| REFERENCE:          | Nova Bus Manuals   |
| RS N°:              | MQR 7621-1266      |

| SUBJECT:       | CNG Exhaust drain                                                       |
| JUSTIFICATION: | Heat from a drain on the exhaust may damage the rear left corner panel. |

Figure 4 - Typical View of Deflector Position Marking

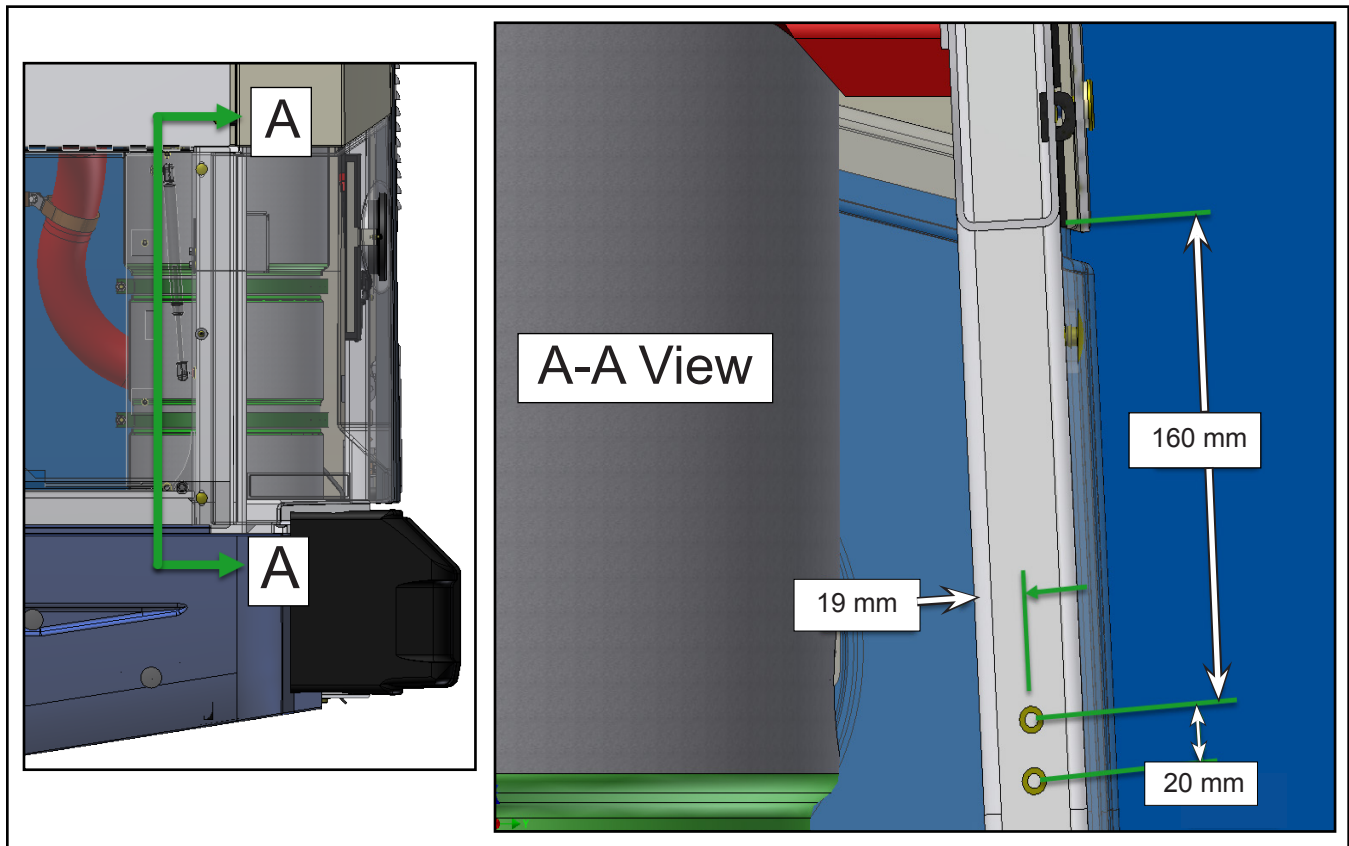
- 1.4. Mark where to drill the holes on the structure tube. Use the deflector as a jig (see Figure 4).

Figure 5 - Typical Location of Drilled Holes (6.7 mm)

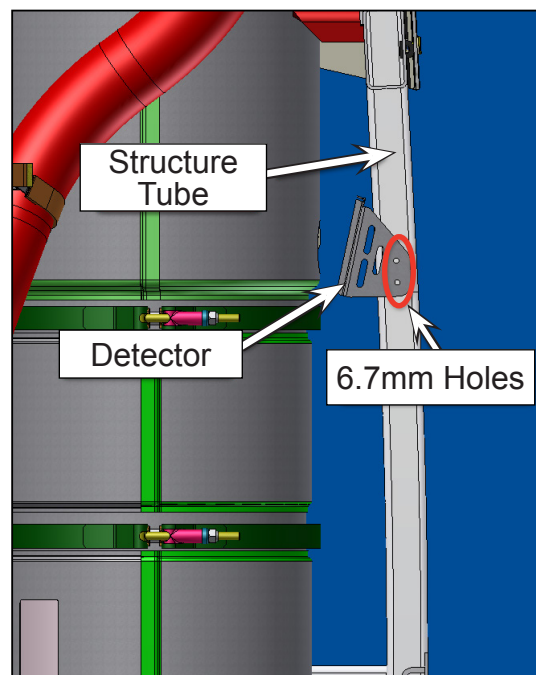
- 1.5. Drill the holes at 17/64 in. (0.265 in or 6.7mm) (see Figure 5).

Figure 6 - Installation of Deflector

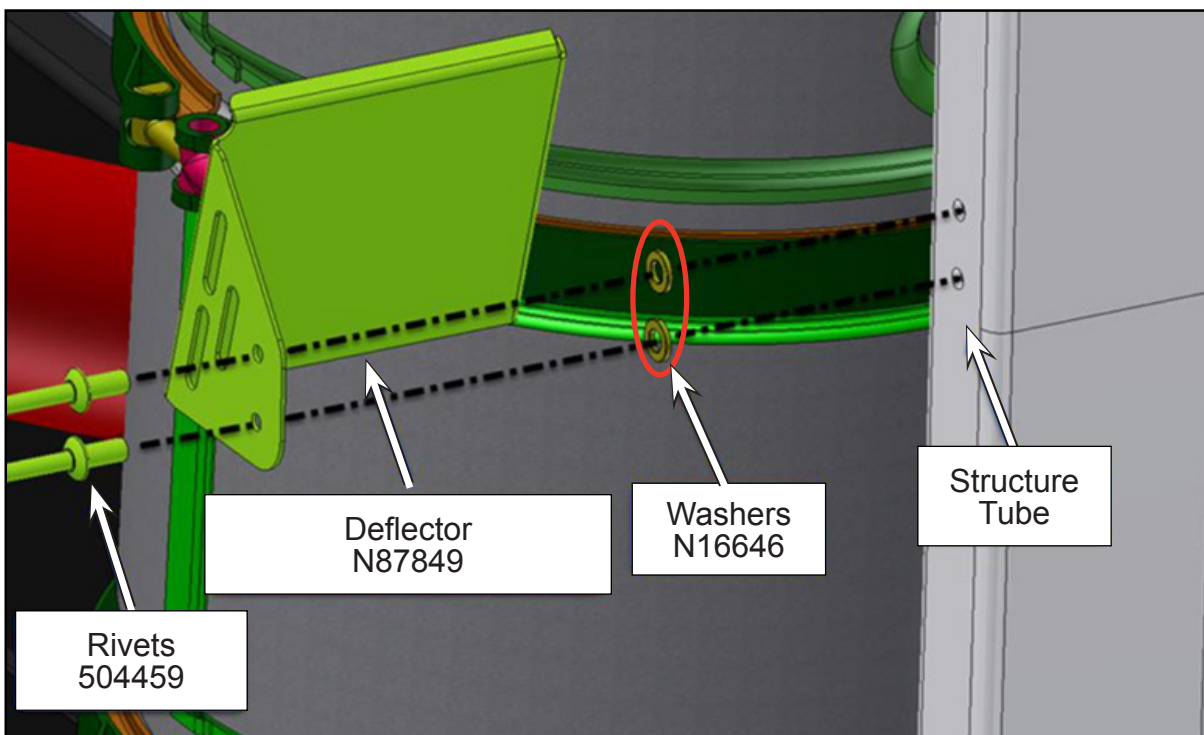
- 1.6. Install the deflector (see Figure 6).

- 1.7. Verify for proper fitment of deflector and hardware.  
1.8. Close the exhaust compartment access panel and the engine compartment access panel.  
1.9. Verify for any leakage and other safety measures.
